PROFESSIONAL SERIES (PRO Z 500, 700, 900)

Subject: **Belt Guide Deck Stabilizer Bracket Kit 759-05902A**

PURPOSE: This Revised Service Kit 759-05902A covers two issues.

FIGURE 1

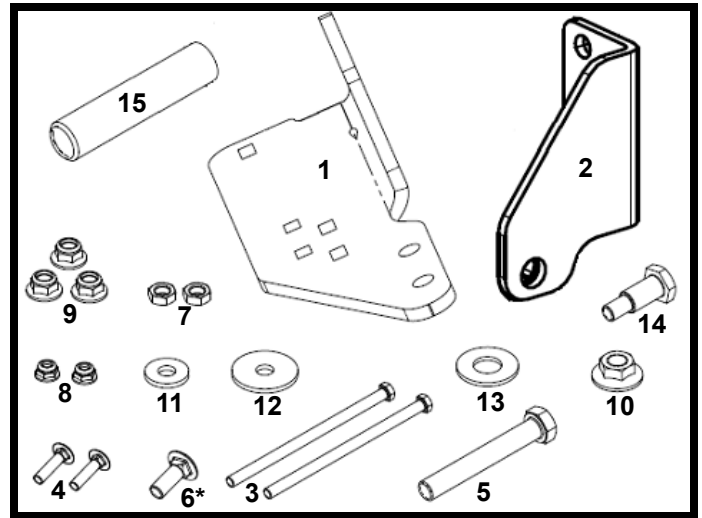
****Issue #2:** Is from recent reports of the dampers of the lap bars interfering with the previous style Deck Stabilizer Bracket (703-24927A) and the idler spring anchor bolt with spacer on the back side of the deck that was previously included in the 753-05902 Service Kit. We have revised the Service Kit 759-05902A with a new deck stabilizer bracket and a shorter shoulder bolt to address both issues.

NOTE: If a Lap Bar Model that previously had the Service Kit 759-05902 installed, its recommended to install the new Deck Stabilizer Bracket and shorter shoulder bolt contained in the 759-05902A Service Kit. The existing hardware or the new hardware contained in the Service Kit may be used for the installation.
